PLANNING BOARD MEETING AGENDA

January 27, 2025 at 7:30 PM

Re: Wickes Arborists – 11 McNamara Road
Response to Site Plan and Special Permit Review comments

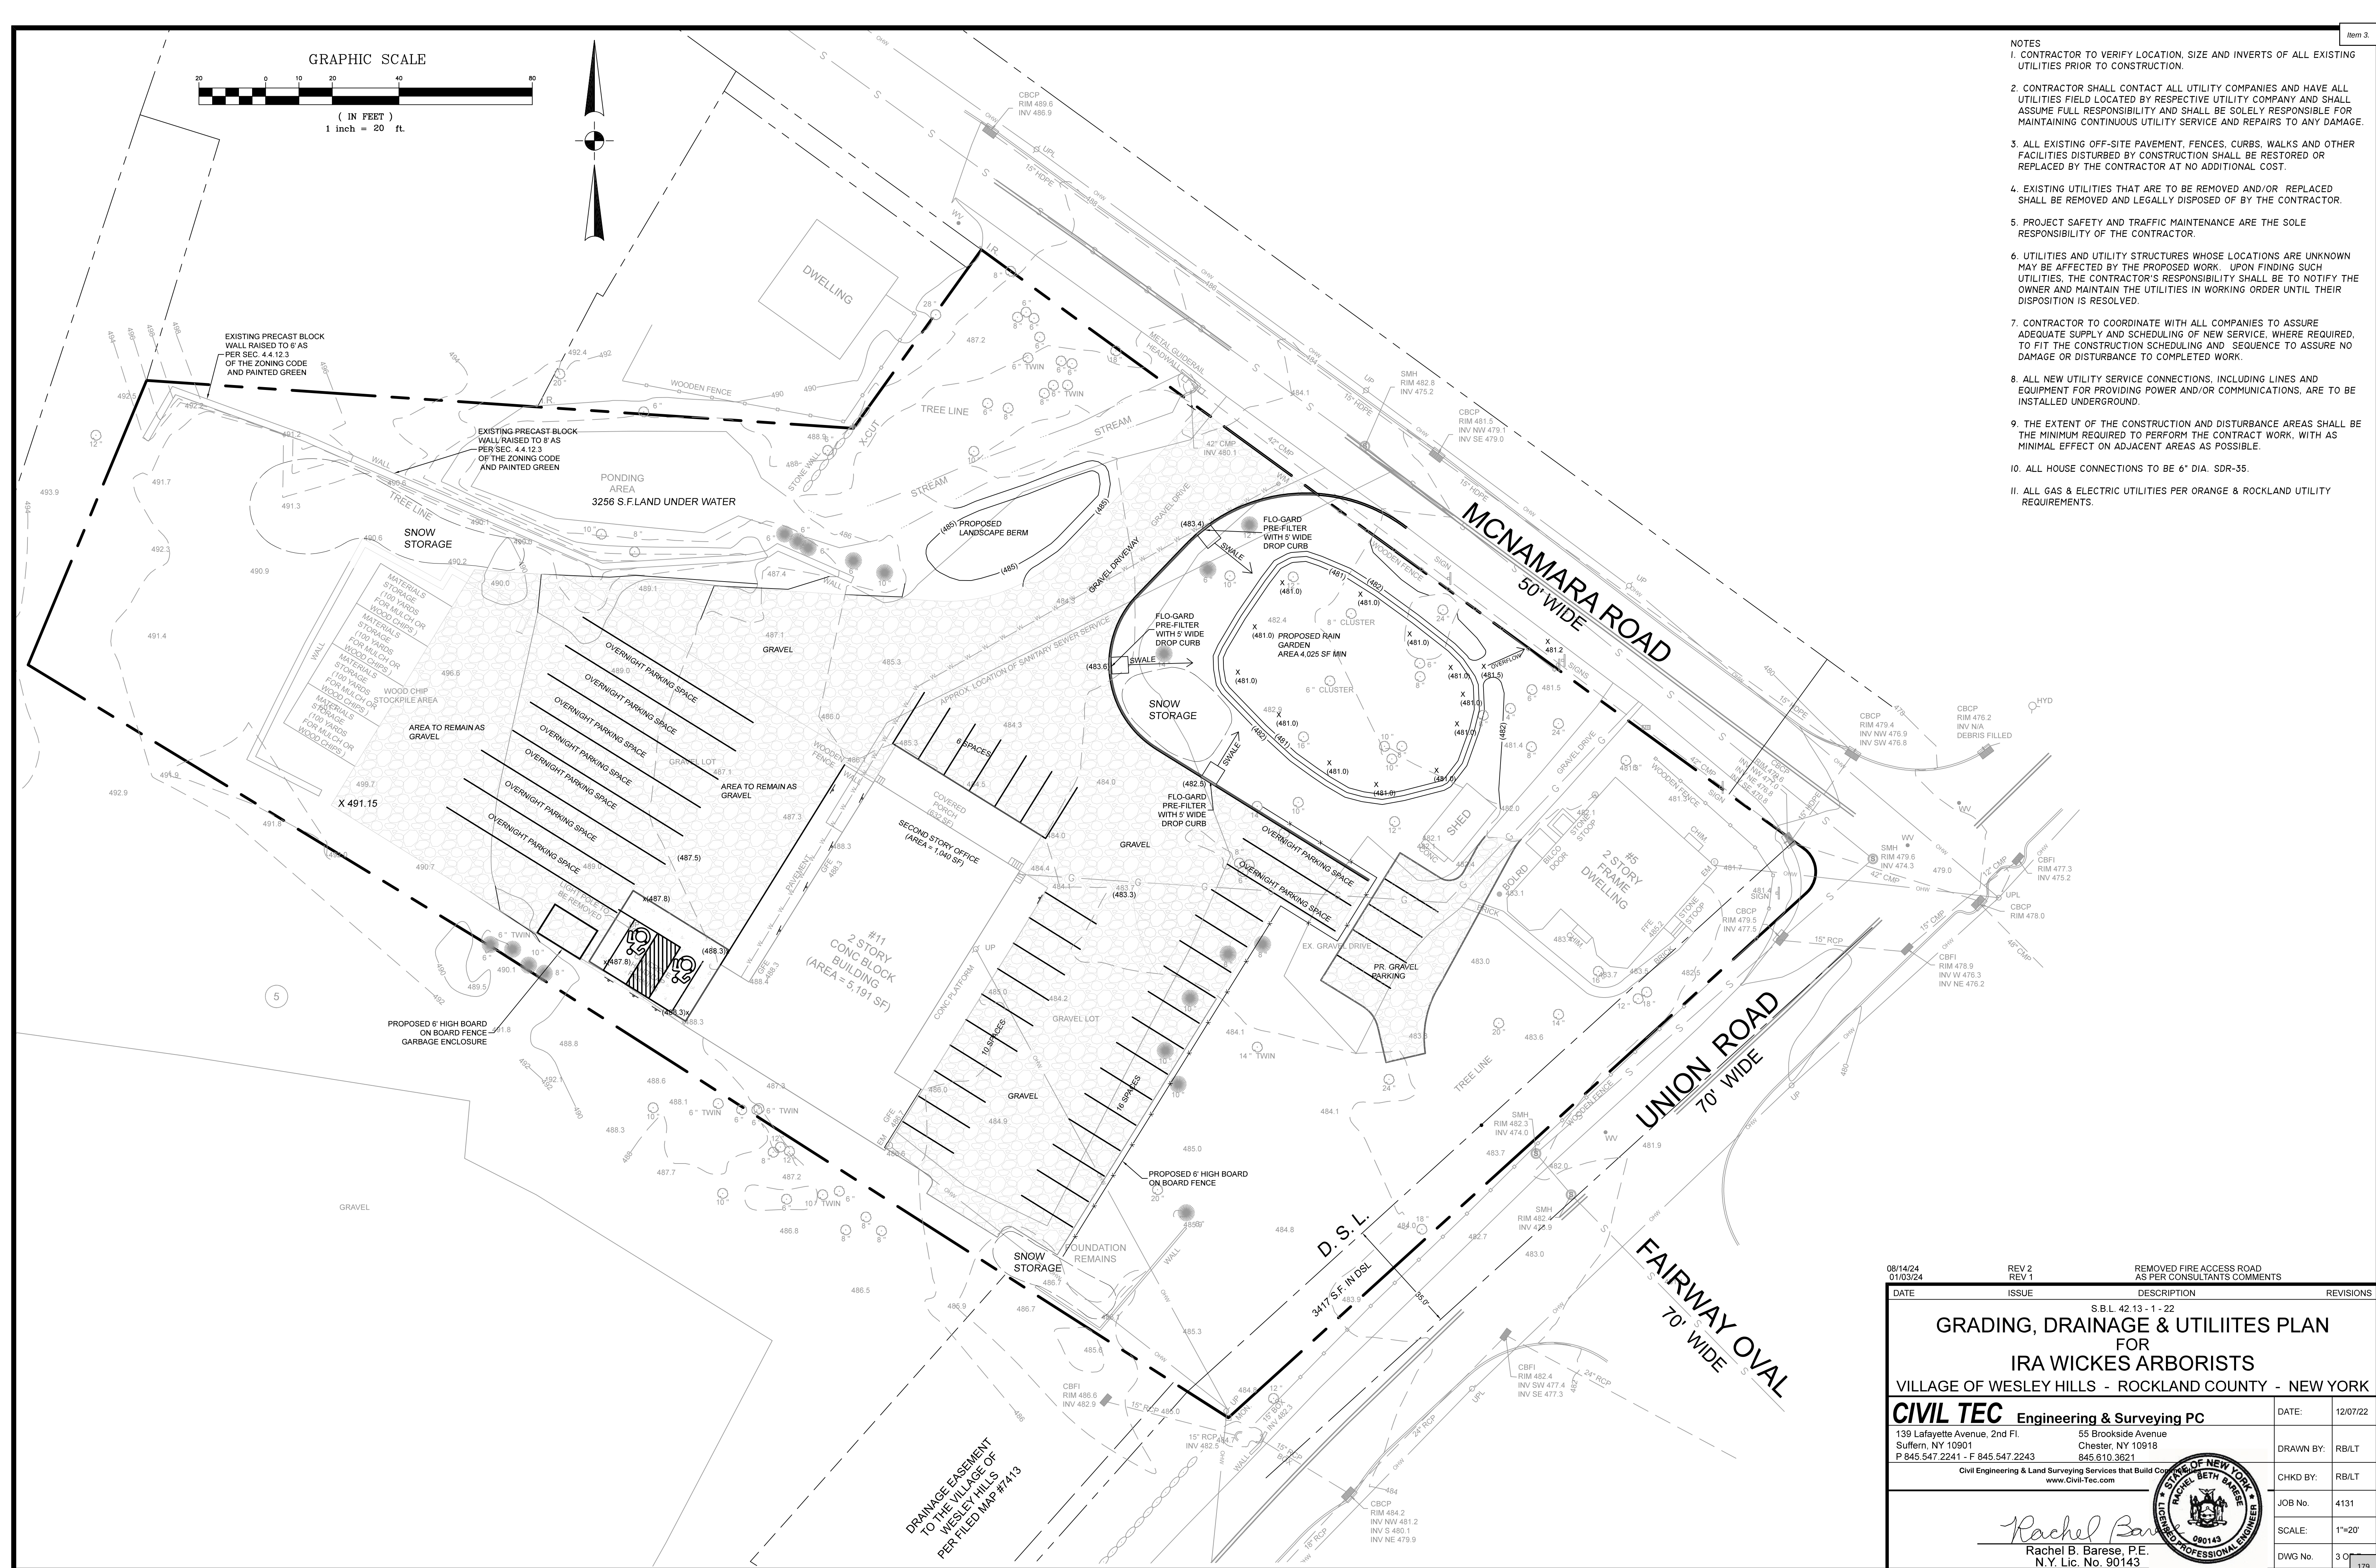
2. Regarding comment 2 of our previous memorandum dated May 22, 2023, **we have no problem with the gated emergency access drive connecting the east parking area to Union Road.** We believe this would satisfy the condition of the Court decision without any undue adverse impact to Union Road. The grasscrete installation will provide a lawn appearance and will not add impervious surfaces to the site. **A comment letter was received from the Fire Inspector dated July 10, 2023, and the latest design on sheet 1 of the site plan set indicates it will be 26 feet in width as requested.**
